SB-10054444-8096

Technical Service Bulletin

SUBJECT:		No:	TSB-13-13-008
MIL ILLUMINATION WITH DTCS P061A/P1235 OR P0068/P1241-REVISED		DATE:	November, 2013
		MODEL:	See below
CIRCULATE TO:	<input type="checkbox"/> GENERAL MANAGER	<input checked="" type="checkbox"/> PARTS MANAGER	<input checked="" type="checkbox"/> TECHNICIAN
<input checked="" type="checkbox"/> SERVICE ADVISOR	<input checked="" type="checkbox"/> SERVICE MANAGER	<input checked="" type="checkbox"/> WARRANTY PROCESSOR	<input type="checkbox"/> SALES MANAGER

This bulletin supercedes TSB-10-13-011, issued November 2010 to add affected vehicles. Changes are italicized and identified by ◀.

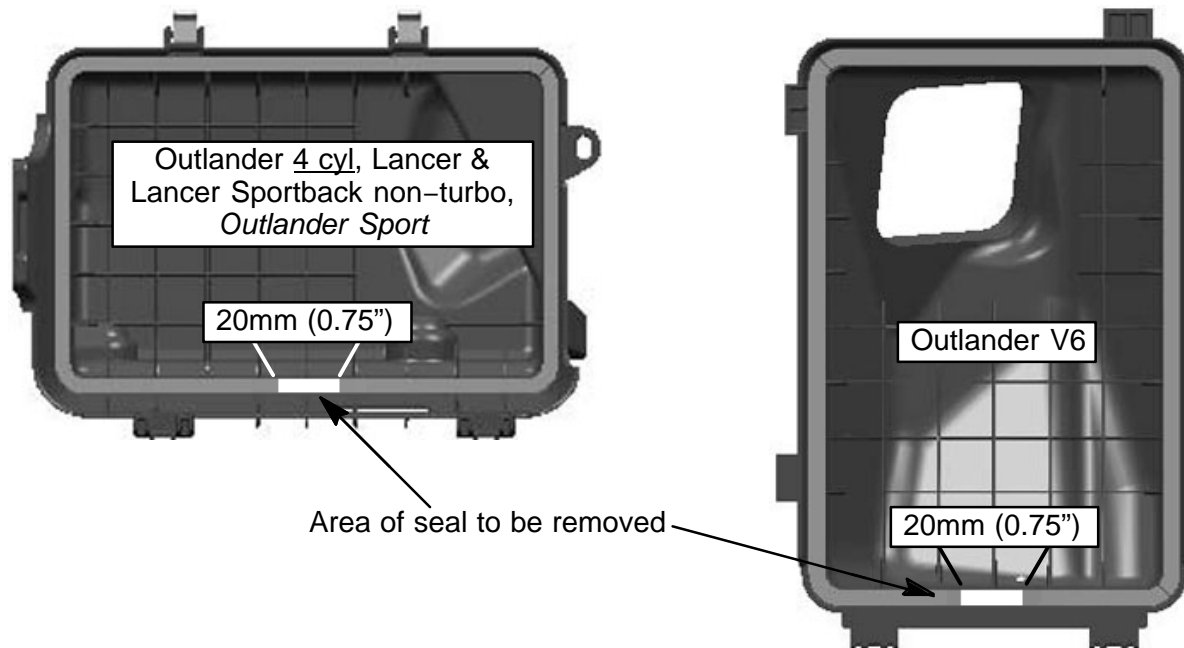
1. Follow procedures in Group 15 – Intake and Exhaust of the service manual to remove the air cleaner cover, air cleaner element and air cleaner body.
NOTE: The air cleaner element will be reused.
2. Place the air cleaner body on a covered work area.
3. Measure a 20mm (approx. $\frac{3}{4}$ ") section of the thin seal at the bottom *center* of the cover (see below).

4. Using a small straight blade screwdriver, lift the indicated section of the seal.
5. The seal has a metal substrate. Remove this section of the seal by cutting it with a small pair of cutters.
NOTE: TAKE CARE TO NOT DAMAGE AREAS OF THE SEAL THAT REMAIN.
6. Use an adhesive cleaner to remove residue from the cut area.
7. Reinstall the air cleaner body. Torque the bolt to 62 ± 27 in/lbs. (7.0 ± 3.0 Nm).
8. Reinstall the air cleaner cover and air filter element.
9. Using MUT-III, erase all DTCs.
10. Start the vehicle and confirm DTCs do not reset.
